## 2015 Michigan Residential Code Errors and Conflicts

The following are errors and conflicts that have been identified at this point. The Bureau of Construction Codes has reviewed these issues. The Director of Department of Licensing and Regulatory Affairs has delegated the authority to make, and has approved, the following interpretations which are advisory.

FIGURE R507.2.1(2)  
PLACEMENT OF LAG SCREWS AND BOLTS IN BAND JOISTS

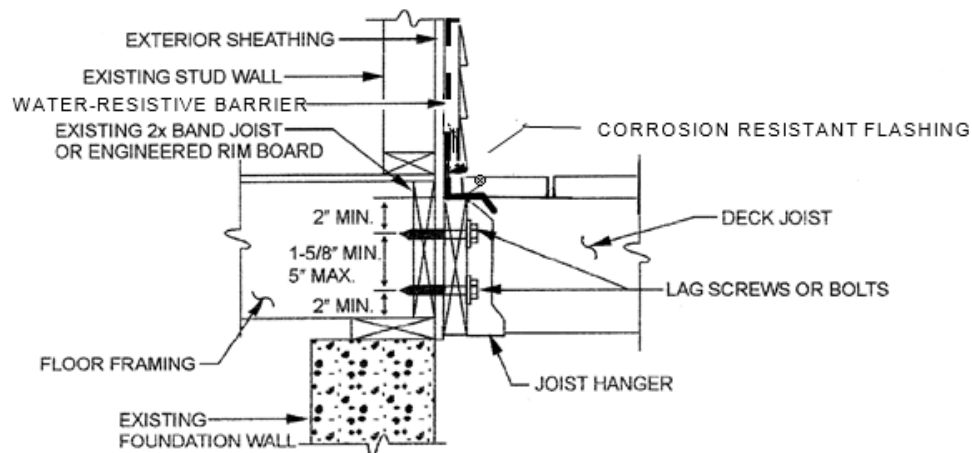
Figure R507.2.1(2) was obviously corrupted during the publication of the rules and was not noticed until it was published by the International Code Council. The figure that must be used by all enforcing agencies is now provided.
